Request for Additional Information No.572, Question 19-365

U.S. EPR Standard Design Certification

Docket No. 52-020

Question 19-365:

**Figure 19-365-1: Hydrogen Mass in Containment for Transient MAAP Case
Ca4_1c_27_25 with 25 percent of PAR Units Available**

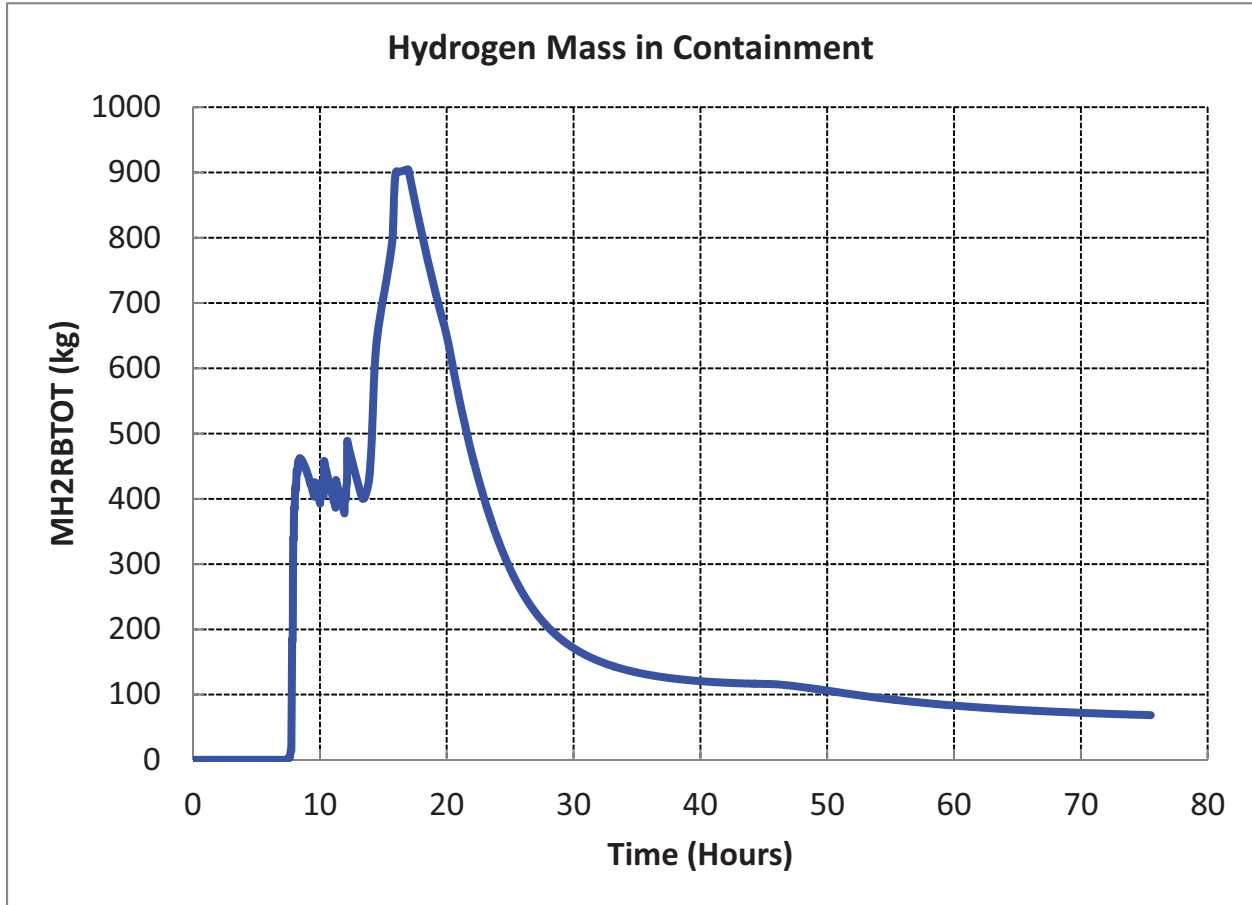
Considering MAAP code uncertainty, the staff is requesting AREVA to add a risk insight to Table 19.1-108, the US EPR Risk Insights, and FSAR Section 19.1.6.3 documenting how many PARs units should be functional and available during shutdown. This risk insight should include information concerning containment locations that are sensitive to high hydrogen concentrations such as the IRWST volume.

MAAP runs with multiple fractions of the large PAR units disabled showed that with all small PARs functioning, and 25 percent efficiency applied to all of the existing large PAR units (equivalent to 75 percent unavailability), the maximum hydrogen mass in containment is determined to be smaller than 1071 kg. This is shown in Figures 19-365-1 and 19-365-2 for transient and LOCA scenarios, respectively. The hydrogen peak masses obtained with 25 percent of the large PAR units available are:

- A hydrogen peak of 905 kg for the transient scenario Ca_4_1c_27_25.
- A hydrogen peak of 796 kg for the LOCA scenario Ca_4_3_27_25.
